Location:	Jack London Square Development Project: Site F3 (south of Embarcadero, between Alice and Harrison Streets, APN 018 042000402).
Proposal:	Final Development Permit for Site F3.
Applicant:	CIM Group, Sean Buran: p: (323) 860-1811
Owner:	CIM Group
Planning Permits Required:	Final Development Permit.
General Plan:	Waterfront Commercial Recreation-1.
Zoning:	C-45 Community Shopping Commercial Zone
Environmental Determination:	Final EIR certified on March 17, 2004 by the Planning Commission; Addendum #1 approved on September 23, 2014.
Historic Status:	None for affected sites.
Service Delivery District:	I – Downtown/West Oakland/Harbor
City Council District:	3 – Lynette Gibson McElhaney
Action to be Taken:	Conduct design review of proposed FDP
Finality of Decision:	NA (Design review, only; No action will be taken at this meeting)
For further information:	Contact case planner Catherine Payne at 510-238-6168 or by e-mail at cpayne@oaklandnet.com

SUMMARY

CITY OF OAKLAND PLANNING COMMISSION

Case File: PUD13170-PUDF03
Applicant: CIM Group
Address: Jack London Square Development Project: Site F3
(Oakland Estuary between Alice & Webster Streets)
Zone: C-45

LANDSCAPE PLAN - GROUND LEVEL
 DESIGN REVIEW COMMITTEE
 Jack London Square - Parcel F3
 CIM Group

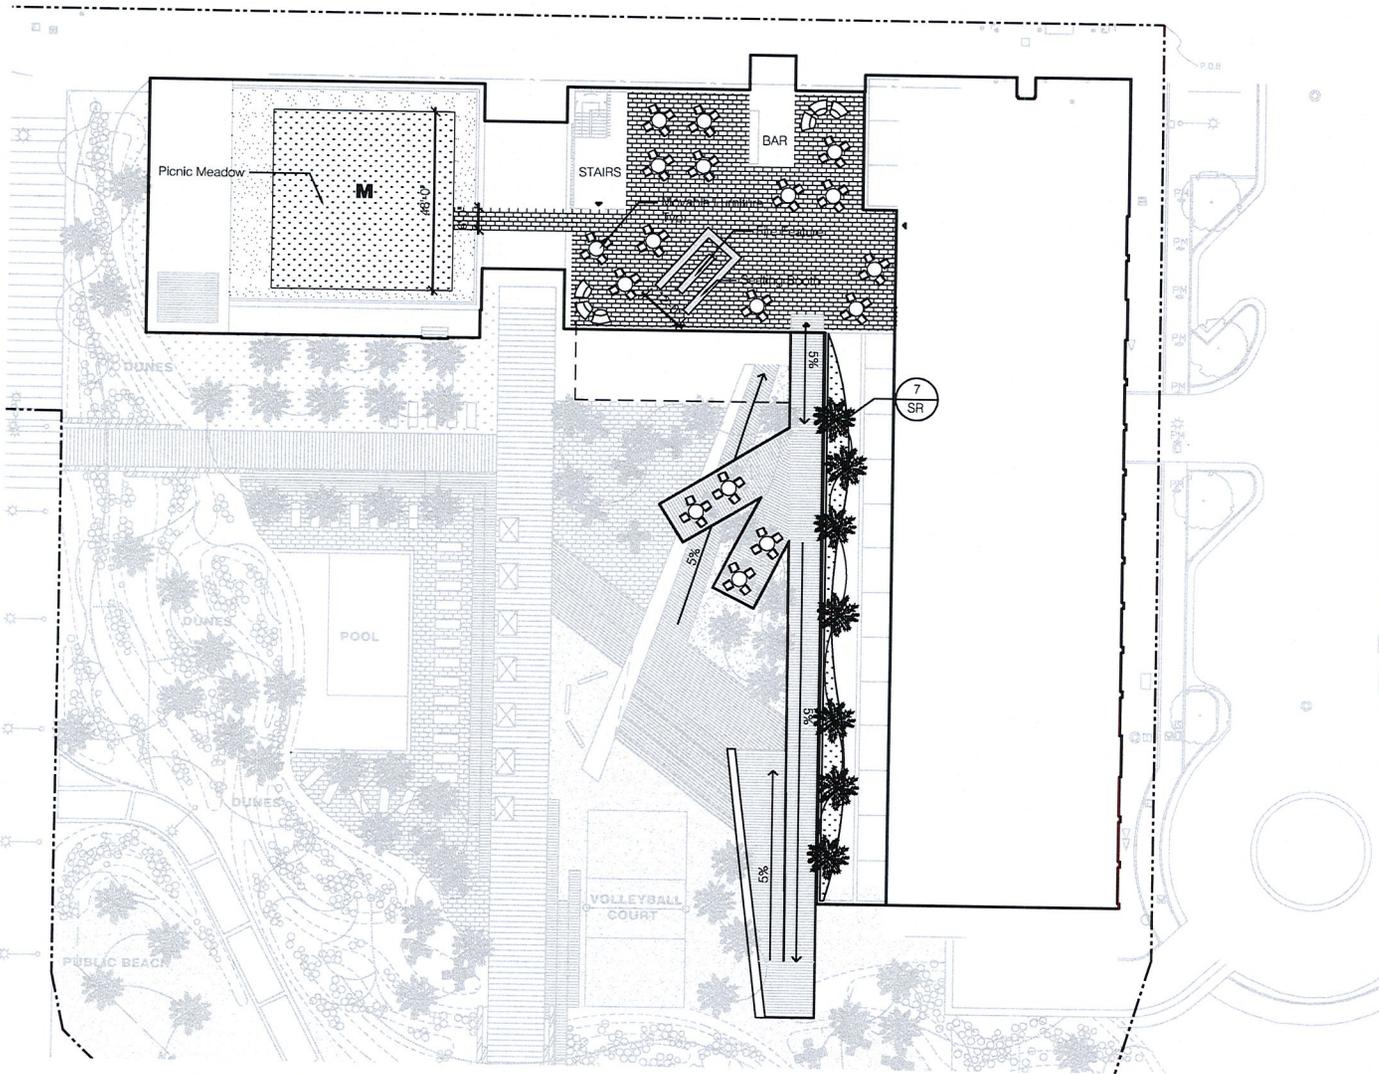
- **Ground floor:** Proposed ground floor uses on Water Street include restrooms, back-of-house offices, private dining room, and meeting rooms at the corner with Harrison Street. These uses do not activate Water Street or provide any porosity between the public and private realms. Staff believes that active uses, like the restaurant and bar should be located along Water Street and, particularly, at the intersection with Harrison Street. Staff has an additional concern that the plans are unclear as to the proposed use for the ground floor space located at the intersection of Water and Harrison Streets: some plans indicate an event space while other plans indicate meeting rooms. The City worked closely with this same applicant to activate the corner of the F2 site at the same intersection and intends to ensure that the entire intersection is designed to perform as an active node for the larger Jack London District.

- **Harrison and Water Street Intersection:** As noted above, Water Street is the primary axis around which the Jack London District is organized and the dining and entertainment heart of the district. The intersections between Water Street and crossing streets, like Harrison Street, should function as highly activated nodes with concentrated commercial uses and connectivity between the private and public realms. This intersection is one of the primary points of access from the surrounding area into the Jack London District and should feel open, busy and welcoming. However, the hotel site planning places the meeting rooms (which could function as an event space) at that important corner. Staff

believes this is an inappropriate use to locate at that corner if the objective is to support the City goal of having a lively entertainment and dining district.

- Dunes: The proposed project includes a dune landscape along the western and southern perimeters of the site. The dunes will provide privacy and protection from the wind for hotel guests. However, without sections and more design information, it is unclear how the dunes would affect the public experience of the water's edge and Bay Trail. Staff is concerned that the dunes would create a fortress-like, unactivated edge that could be uncomfortable for the public. The current design includes two points of entry between the hotel and the public Bay Trail. Staff requests further information about the dune design and further exploration of the interface between the hotel site and the Bay Trail.

The proposed Site F3 hotel plans suggest a canopy feature over Water Street. Staff is concerned that this feature will make the pedestrian paseo feel private. Staff requests a more complete design of Water Street to ensure that the space will be a successful public facility for visitors to the Jack London District. Water Street should be designed to convey continuity with the paseo to the north, and to be a welcoming public space.

LANDSCAPE PLAN - LEVEL 2
 DESIGN REVIEW COMMITTEE
 Jack London Square - Parcel F3
 CIM Group

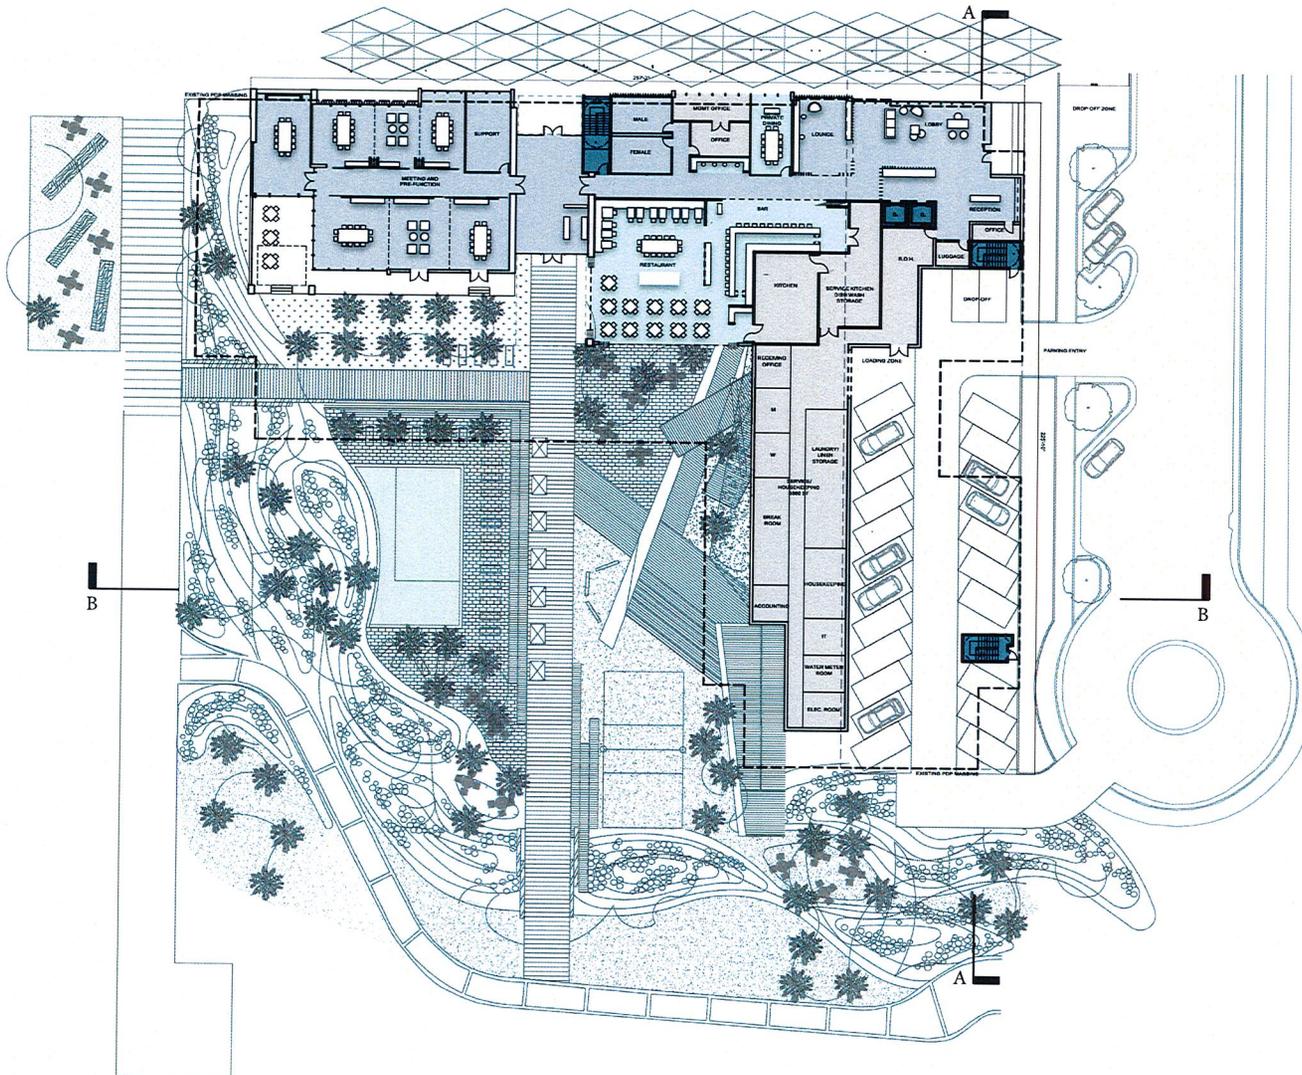
- **Second floor:** The proposed hotel bar is located on a roof deck along Water Street. The bar is designed to be a unique, destination space providing views to the Estuary and San Francisco beyond. However, this outdoor bar would also be located across from the upper levels of residential townhouses facing the opposite side of Water Street. The bar could be noisy and otherwise present a nuisance for residential uses on the opposite side of Water Street.
